Revised Aesthetic Improvement Planting under Viaduct Structure (OM6)

LIANTANG/HEUNG YUEN WAI BOUNDARY
CONTROL POINT AND ASSOCIATED WORKS
(SITE FORMATION AND INFRASTRUCTURES)
- DESIGN AND CONSTRUCTION

Revised Aesthetic Improvement
Planting under Viaduct structure
(Sheet 1 of 3)

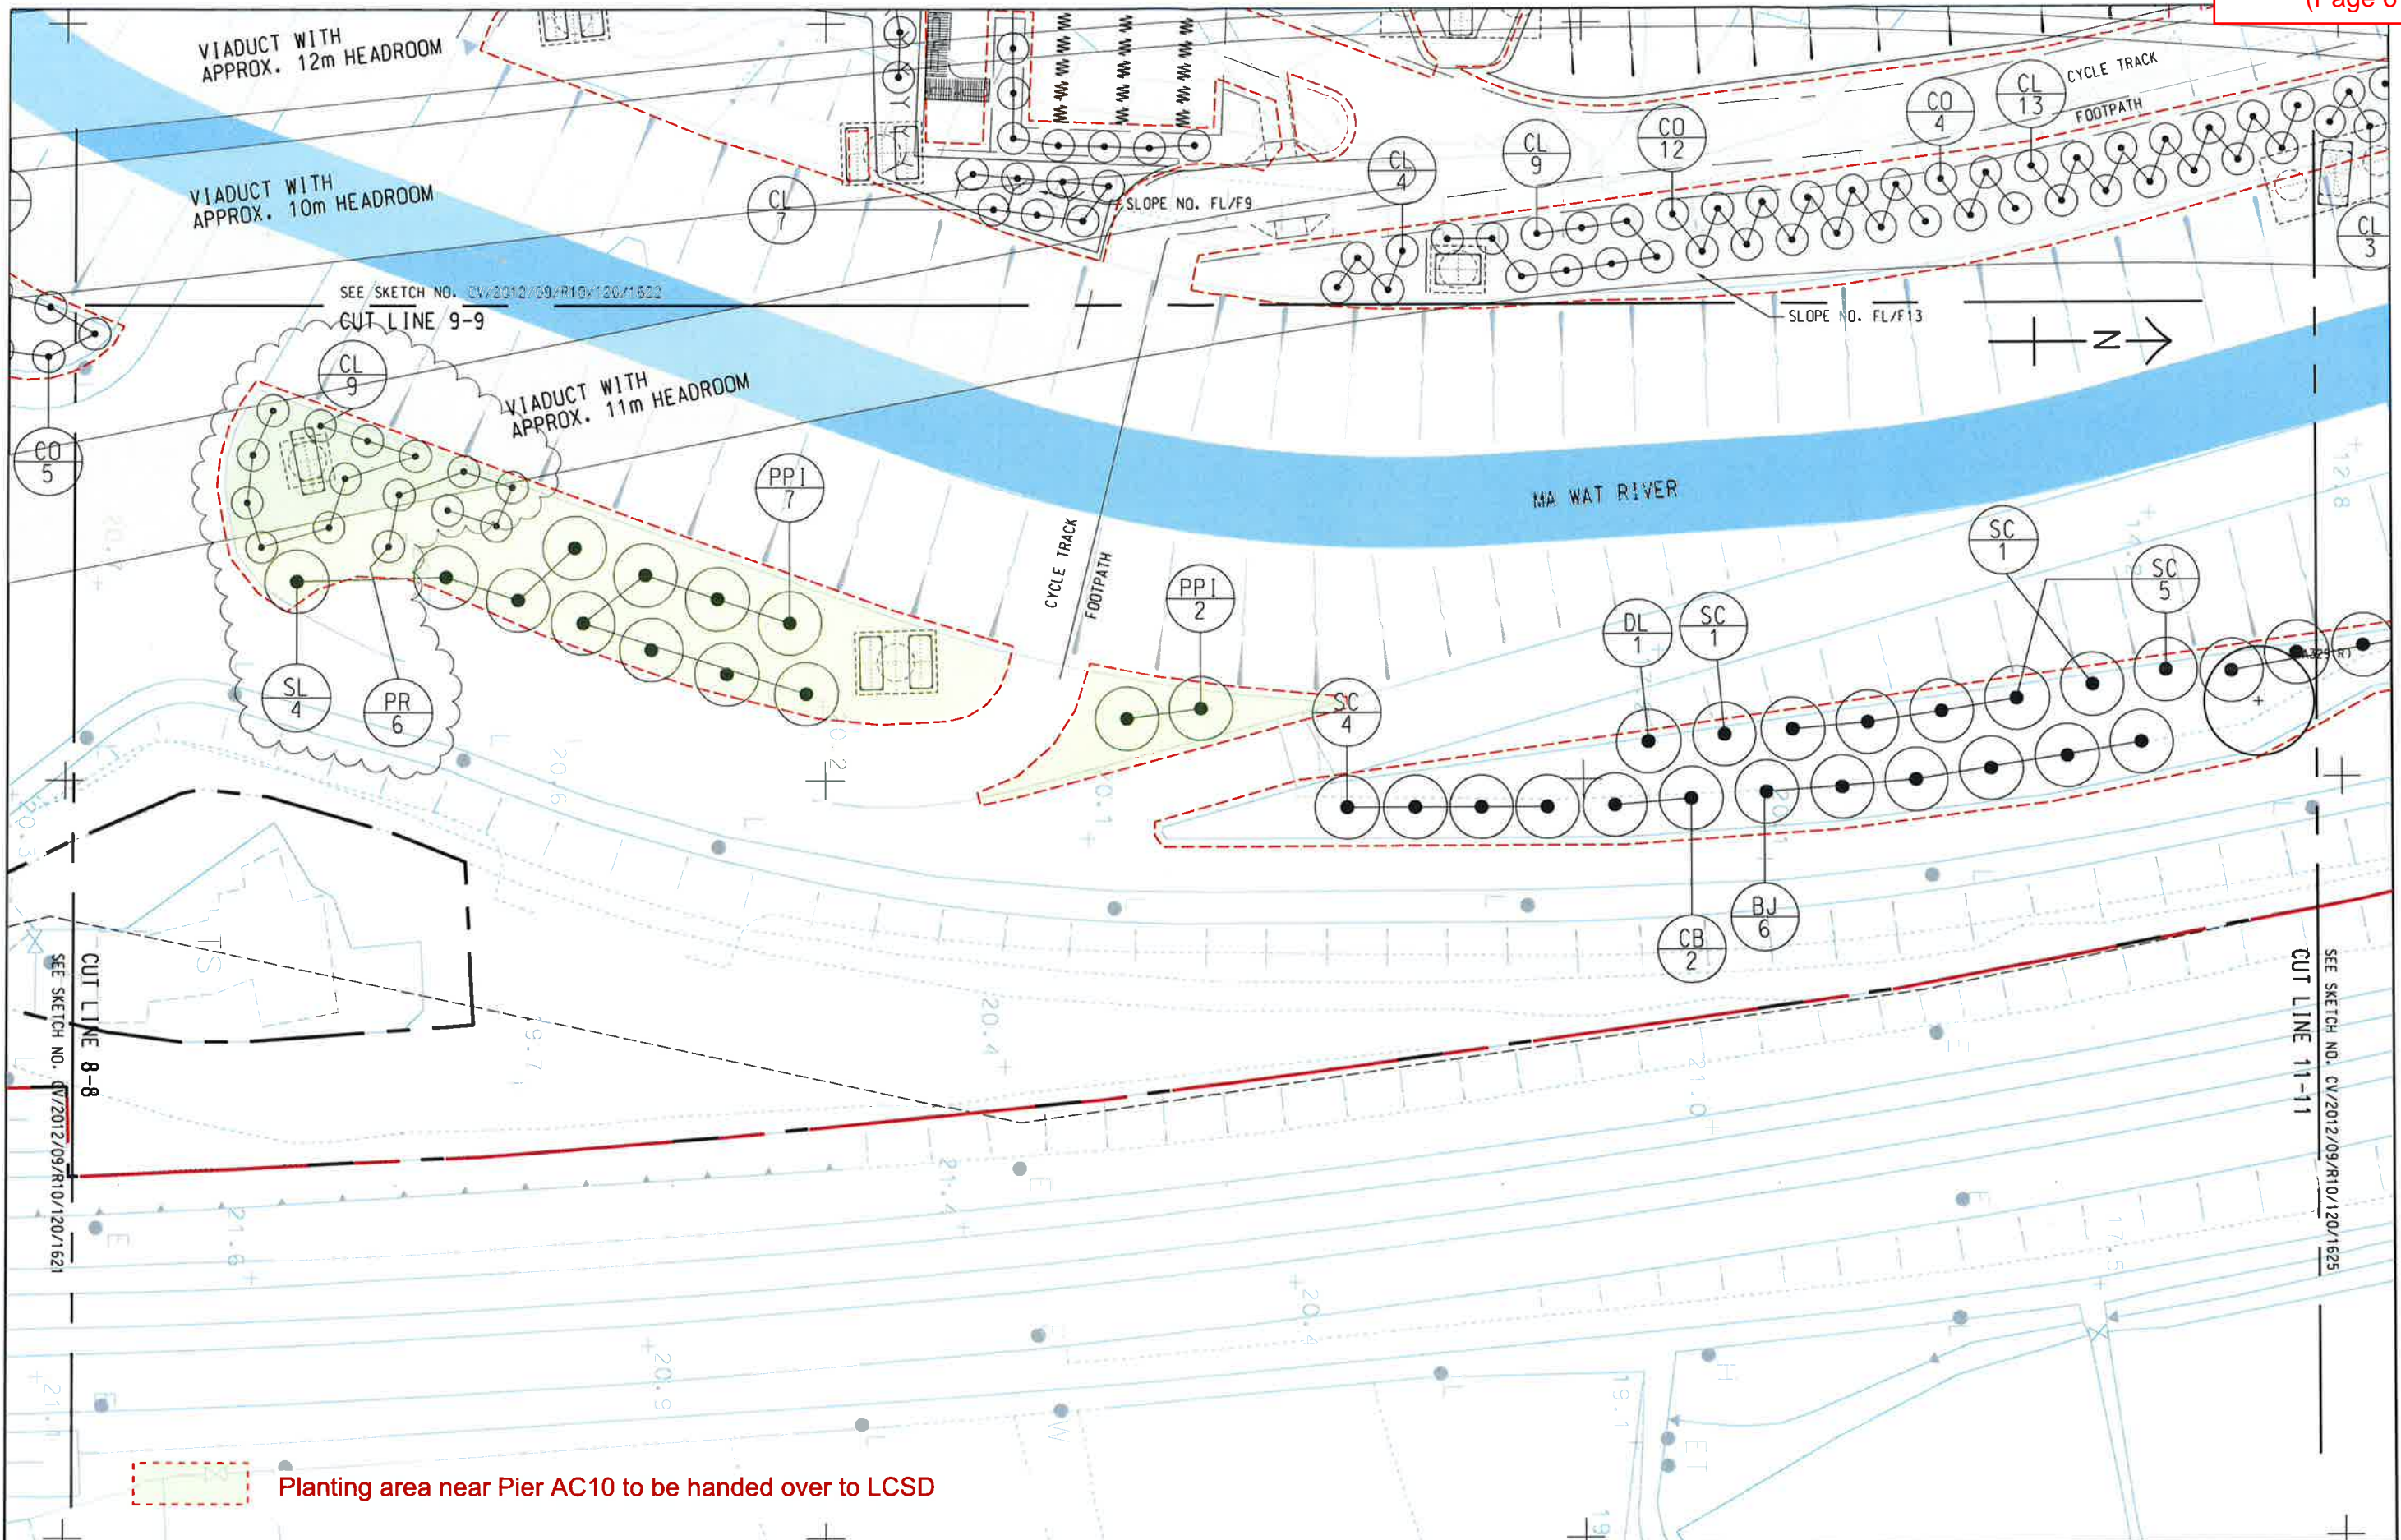
Proposed locations of 3nr new *Sterculia lanceolata* were observed to be covered by the as-built viaduct, of which direct sunlight is not available.

Therefore, we proposed to omit the 3nr new trees planted underneath and replace with 6nr *Phoenix roebeni* at 3m spacing.
